<b>Title - Sujet</b> Resin Tanks	
<b>Solicitation No. - N° de l'invitation</b> F5243-170239/A	<b>Amendment No. - N° modif.</b> 001
<b>Client Reference No. - N° de référence du client</b> F5243-170239	<b>Date</b> 2017-12-07
<b>GETS Reference No. - N° de référence de SEAG</b> PW-\$STJ-005-4233	
<b>File No. - N° de dossier</b> STJ-7-40129 (005)	<b>CCC No./N° CCC - FMS No./N° VME</b>
<b>Solicitation Closes - L'invitation prend fin</b> <b>at - à 02:00 PM</b> <b>on - le 2018-01-09</b>	
<b>Time Zone</b> Fuseau horaire Atlantic Standard Time AST	
<b>F.O.B. - F.A.B.</b> <b>Plant-Usine:</b> <input type="checkbox"/> <b>Destination:</b> <input checked="" type="checkbox"/> <b>Other-Autre:</b> <input type="checkbox"/>	
<b>Address Enquiries to: - Adresser toutes questions à:</b> Lomax (STJ), Sandra	<b>Buyer Id - Id de l'acheteur</b> stj005
<b>Telephone No. - N° de téléphone</b> (506) 636-4362 ( )	<b>FAX No. - N° de FAX</b> (506) 636-4376

This Tender Amendment No. one (1) is raised to include the following Addendum No. one (1).

### **QUESTION AND ANSWERS**

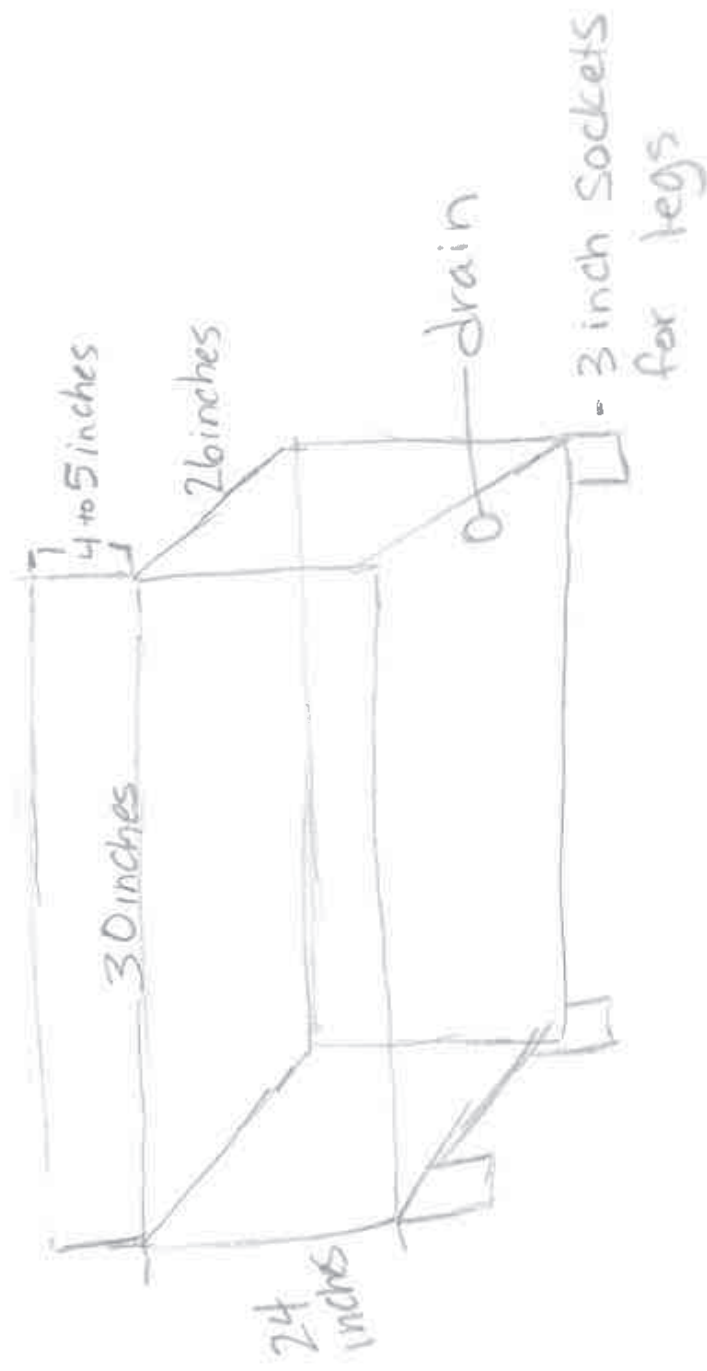
Q1. #3 of the Annex "C" states that: "The tanks must have an iso gelcoat interior and exterior for marine application and must be fabricated with isophthalic resin throughout for consistent temperature exceeding 14°C." The 14 degree seems to be a typo and it should be 140 degree (as it is mentioned in the section 1.3 Objectives of the Requirement of the Annex "A"). Would you please clarify or confirm?

A1. The 14 °C is correct.

The intent is to have the resin holds tank temperature at a constant above that temperature with no breakdown of the resin. Most marine resin is not held to the standard of >14 °C (salt water is usually colder), however the climate change research being done in these tanks can be above normal temperatures and is extremely sensitive to even slight temperate variances so it is very important that the isophthalic resin be used. We have current tanks with this resin and it is the only ones that have proven to give the consistent temperature properties we require.

Not to Scale

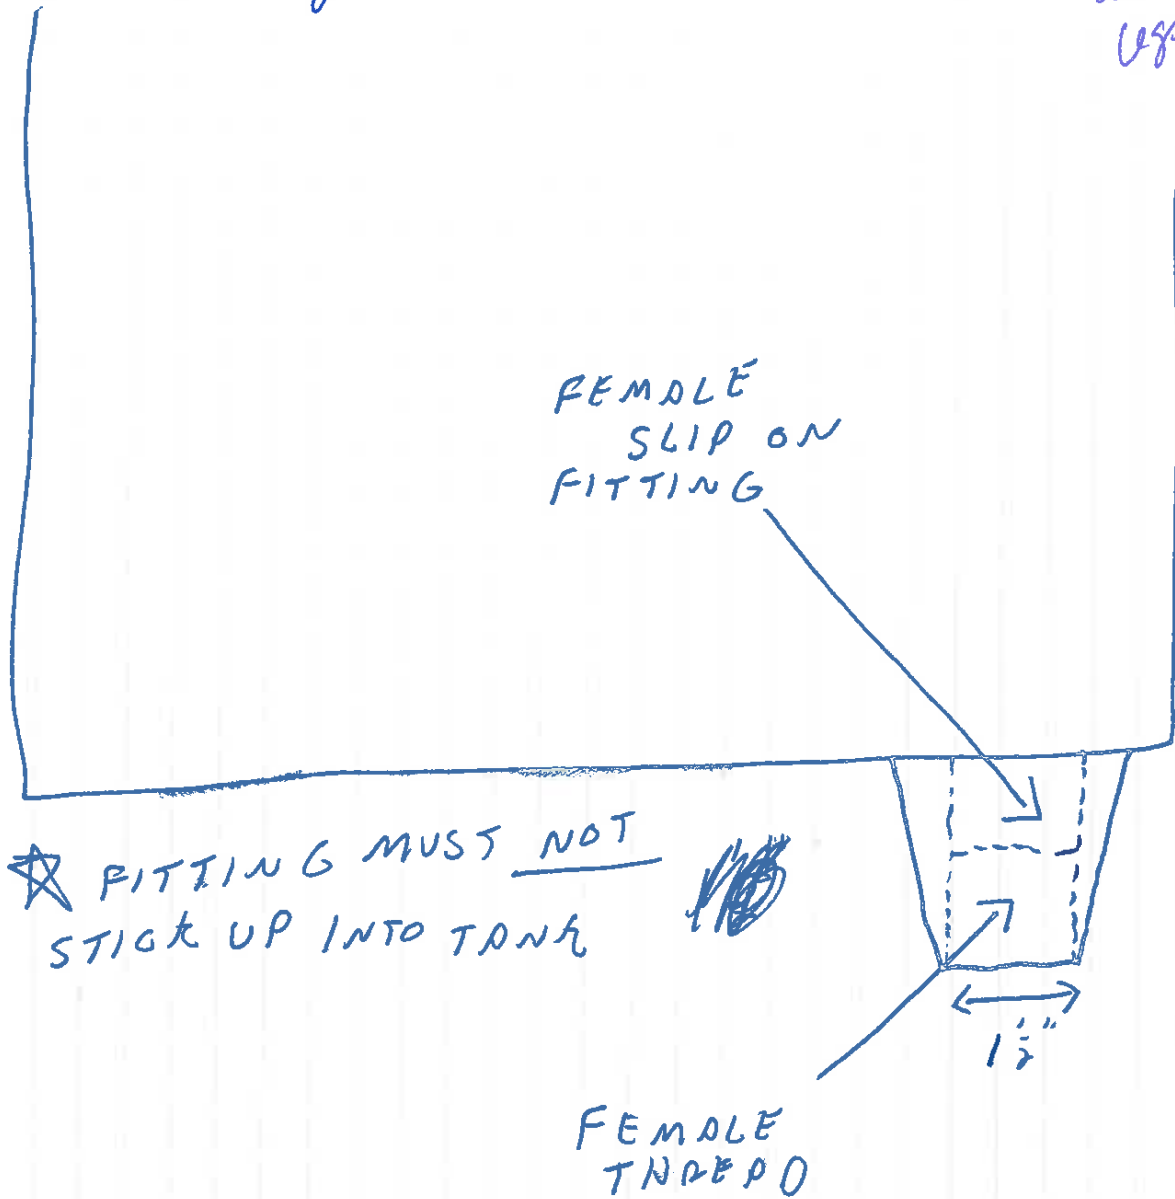
Q1. Are there drawings or photos of existing tanks that we can view as reference? Is there a hatchery on Vancouver Island that has these in use?

(40" to top  
of tank)  
Ask for PVC  
legs included?

★ SAME FOR 2" DRAINS  
ON LOBSTER TANKS

A1. This is new space and no existing tanks to connect to. I could not tell you if Vancouver Island hosts any of these tanks. We do have tanks in another area of our wet lab made from the same resin which is why we know this is the resin we need to hold up under the conditions of the lab. Attached is a photo of an existing tank and a sketch.
